# PARKSIDE P.R.U.D. PHASE 1

# THE BRIDGES - PHASE 1

## PRELIMINARY CONSTRUCTION DOCUMENTS EDEN, WEBER COUNTY , UTAH

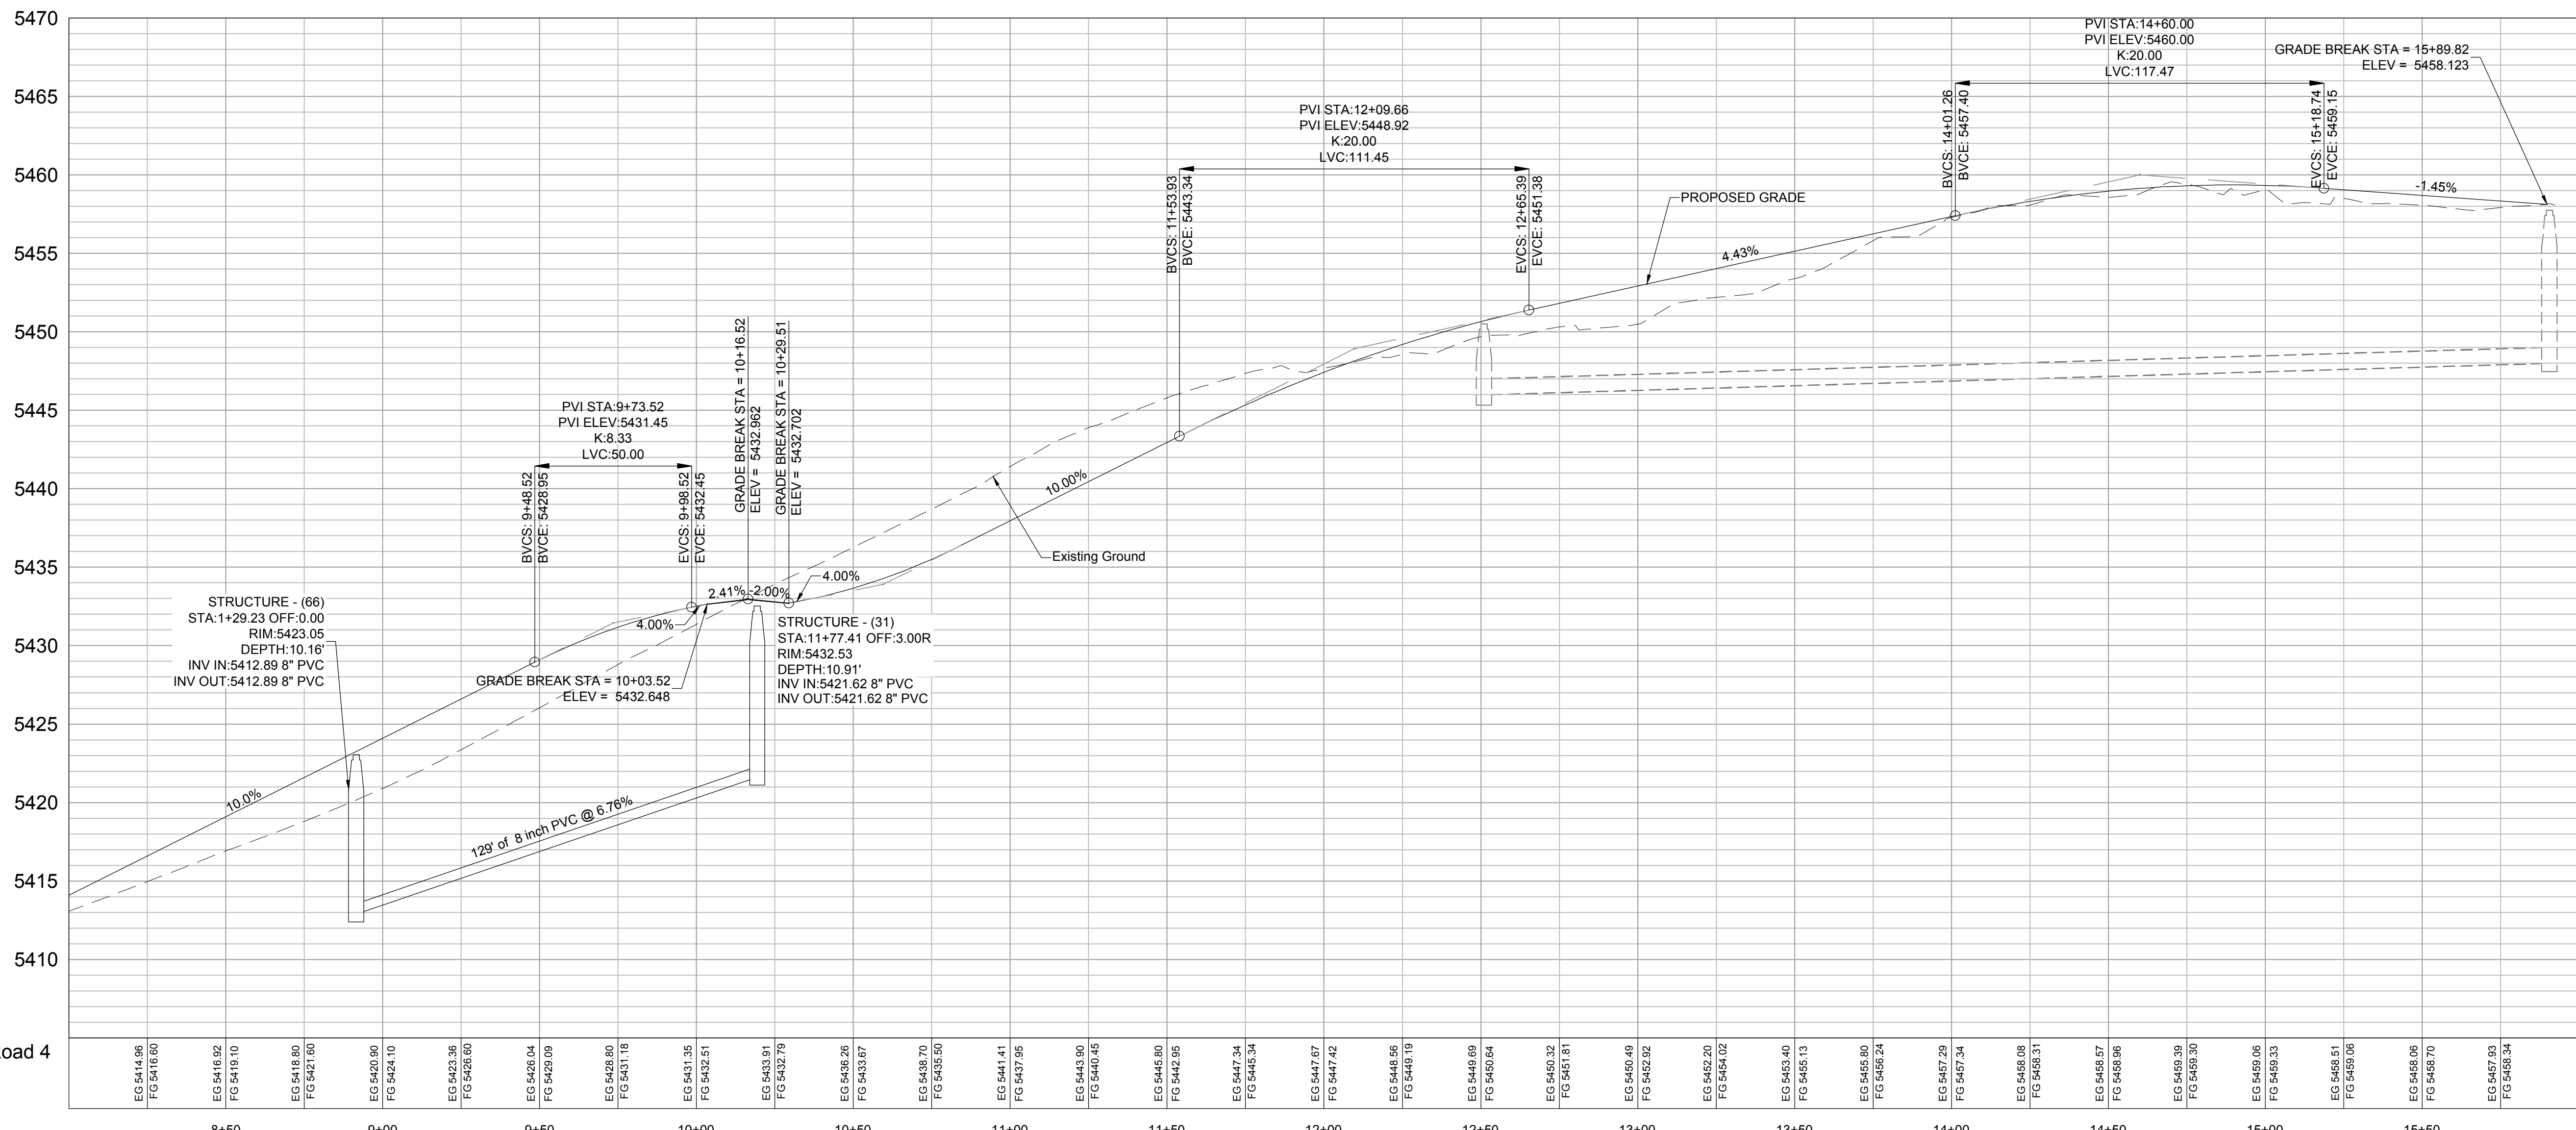
Isn't there drainage that comes down through here? Will it go into the swale? Will it be able to handle the flow? There could potentially be a lot of water come off the hillside.

Will the storm drain be sized adequately, depending on the comment to the right?
